Review Memorandum

Subject: LUPC Stormwater Review (Application #: RP 3313)

Project: Beaver Cove Access Road (STI # 250115)
Burnt Jacket Road
Beaver Cove, ME
Map, Plan, and Lot # 001-001-A

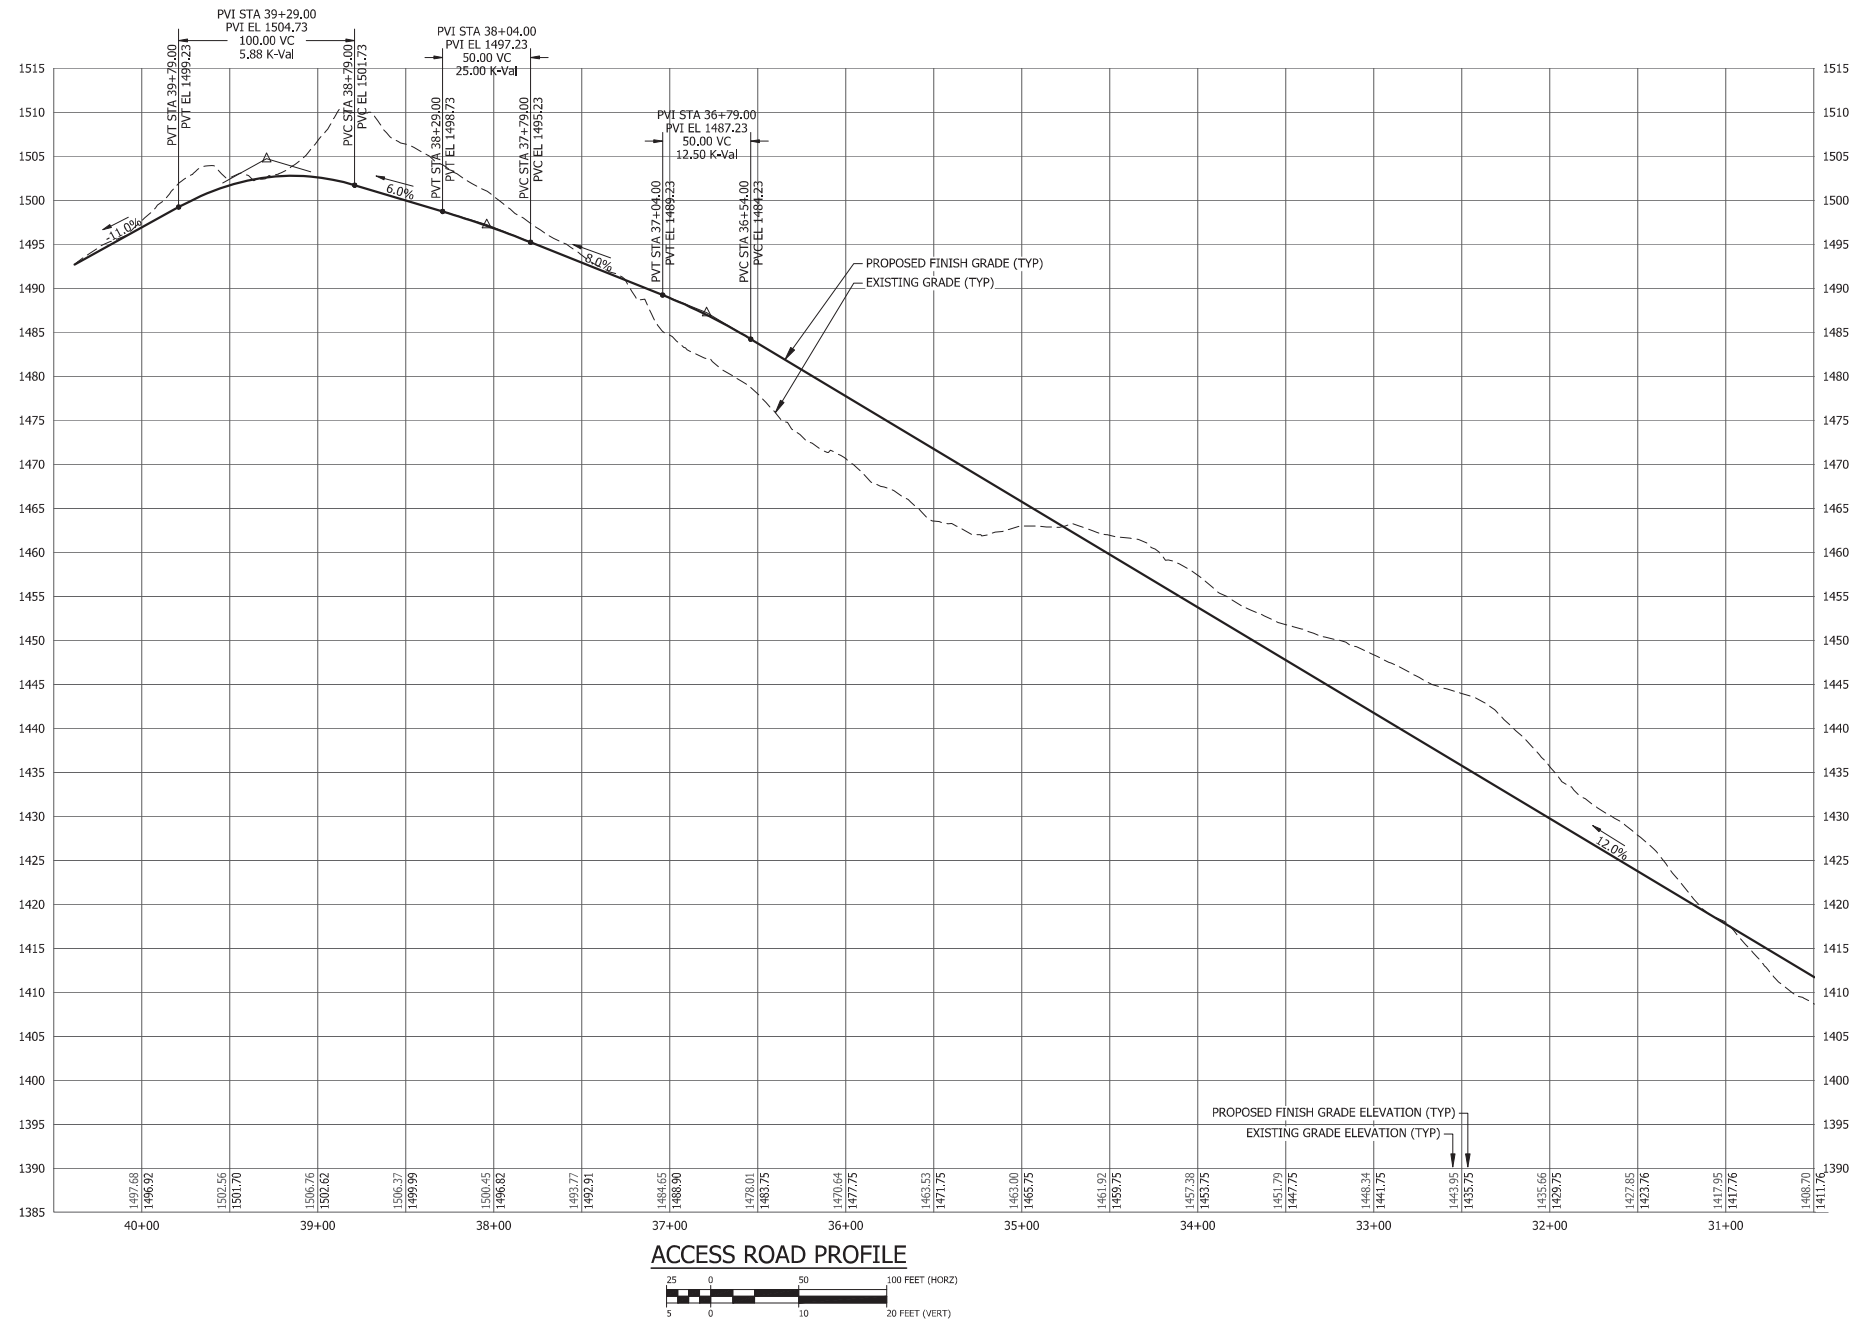
- *STI Comment: Plan Sheet C-201 and C-203 should be revised to show the riprap ditch lined up with the swale indicated by the grading. On sheet C-203, the swale appears to diverge from the road around STA. 36+00 while maintaining a slope of 12%. The riprap ditch should extend through this section. Additionally, from station 39+00 to station 30+00 there is no planned relief culvert. It is recommended to follow the ditch relief culvert spacing and alignment standard outlined in LUPC Chapter 10.27 D. Roads and Water Crossings given the steep slope of the roadway.*

STI Response: Please see the attached markup showing the flow path of stormwater as the ditch is currently designed near STA 36+00. It is acceptable to use erosion control mesh on

the side slopes, however, channelized flow needs to outlet to a level spreader prior to being discharged to downstream areas. Please provide updated plans and a level spreader detail.

SME Response: The proposed driveway is in a fill section at Station 36+00. The intersection of the fill embankment with existing ground represents the bottom of the ditch. In areas of fill on the uphill side of the road North American Green (NAG) P-300 permanent erosion control matting will be installed on side-slopes. In areas of fill on the downhill side of the driveway, NAG S75 matting will be installed on side-slopes until vegetation is established. Additional callouts will be added to Drawings C-201 and C-203 accordingly. Drawing C-301 will be updated to show a detail for North American Green S75 matting.
